SERVICE BULLETIN

No. 280

Subject: Case leakage of R. C. Allen 3" Artificial Horizon
(See attached R. C. Allen Inc., Service Bulletin No. 1.)

SERVICE BULLETIN
FOR
ARTIFICIAL HORIZON
MODEL RCA 21

Figure 1. Application of Pressure Sensitive Tape.

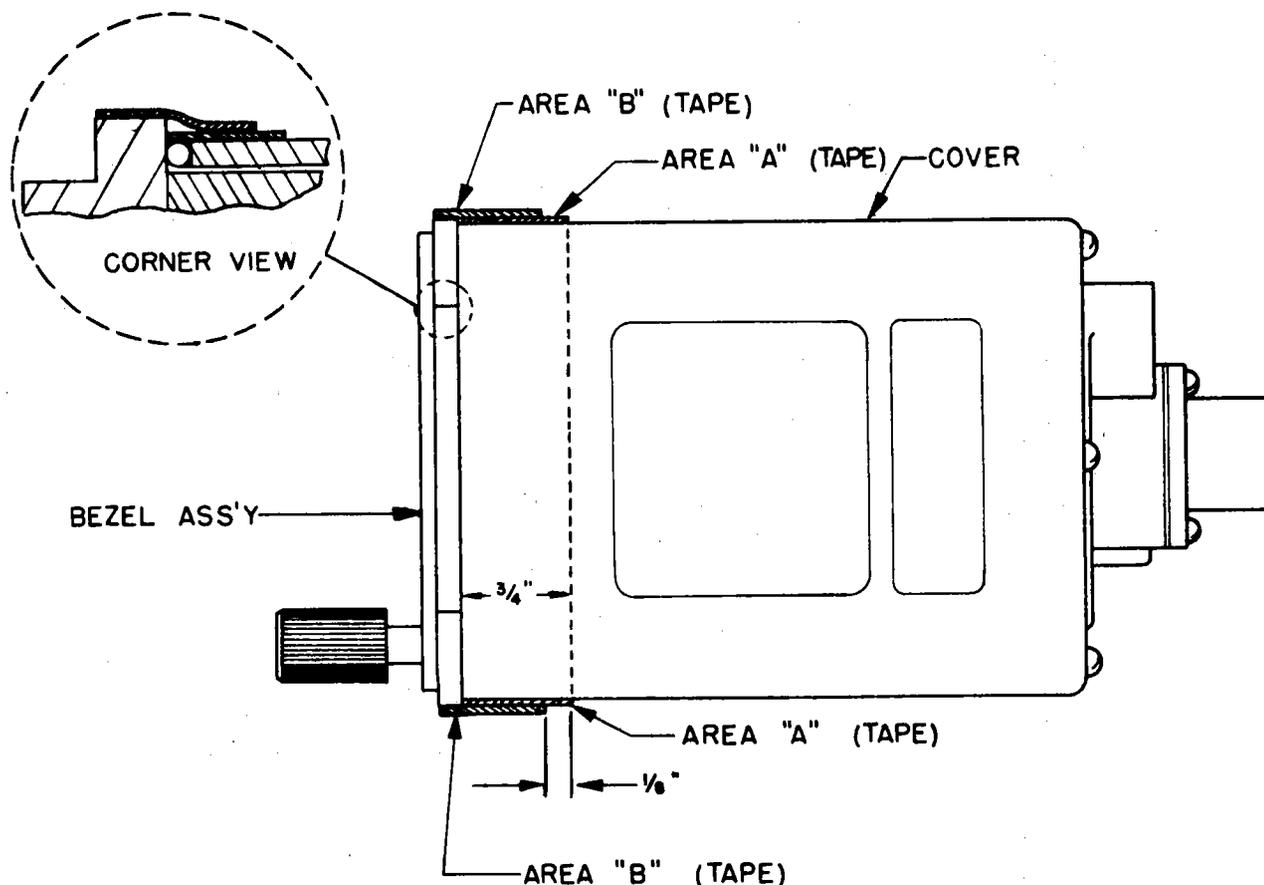
Some deterioration of the gasket used to seal the case to the bezel has been experienced. Such deterioration may occur due to the action of ozone and/or the action of certain solvents to which the gasket may have been exposed. If not corrected, the deterioration may result in leaks which can lead to reduction of vacuum system pressure, sluggish horizon performance and eventually complete failure of the gyro system.

2. Refer to Figure 1 and apply one wrap of pressure sensitive tape, 3/4 inch wide, around the horizon as shown in Area "A". Pull the tape as it is being applied so that a slight amount of stretching occurs. The edge of the tape must butt against the rear surface of the bezel assembly and lay firmly against the cover. Overlap the tape approximately two inches.

3. Again refer to Figure 1 and apply one additional wrap of the tape over that just applied as shown in Area "B". Apply this wrapping so that the edge of the tape is flush with the front surface of the bezel assembly. Stretch as required so that the tape lays smoothly around the irregular corners of the bezel. Overlap the tape approximately two inches.
